ADDENDUM No. 1

PROJECT: Blacktail WMA North & West boundary Fence

FWP #599302

DATE: June 6, 2012

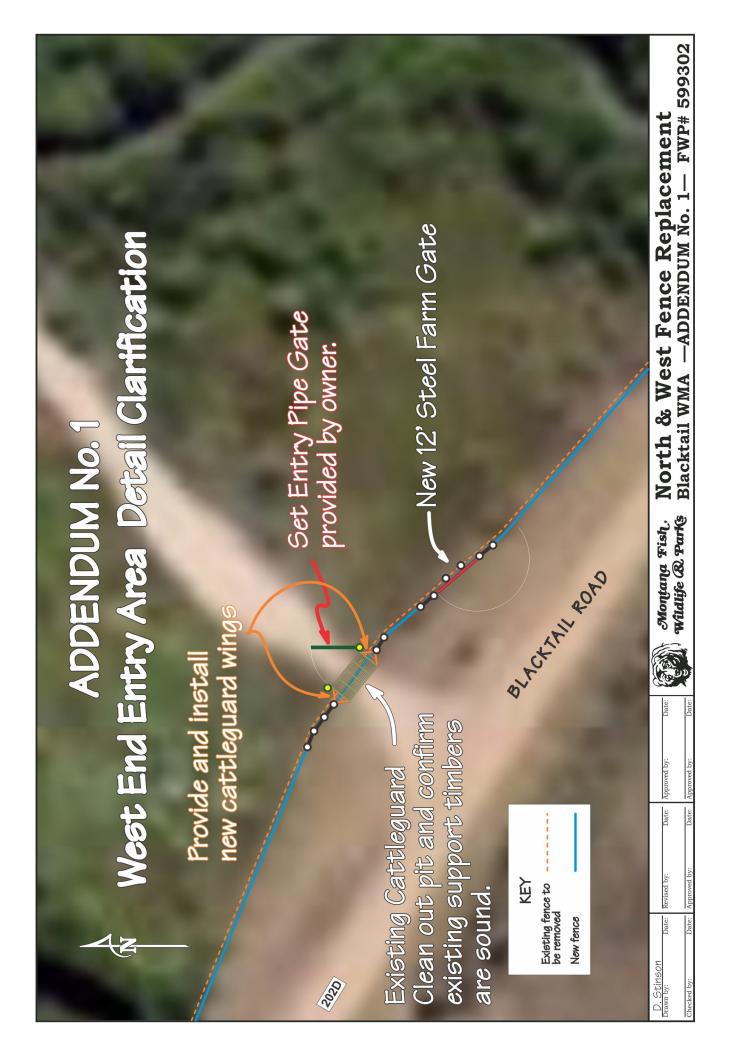
New Item 12 is one 12' steel farm gate with two single panel braces and two posts behind the gate to block vehicular use. This is to be provided and installed adjacent to cattleguard location as shown in Addendum drawing following.

- a) Cattleguard pit is assumed to have serviceable timbers. Timbers will be evaluated after excavation of pit. Any required replacement of timbers would be considered as a Change Order at that time.
- b) Cattleguard will require new wings, as the current cattleguard does not have wings.
- c) Steel pipe entry gate in this item is described on page 10 of 11 of drawings. This gate will be provided on-site by the owner and is to be set adjacent to the cattleguard as shown in Addendum drawing following.
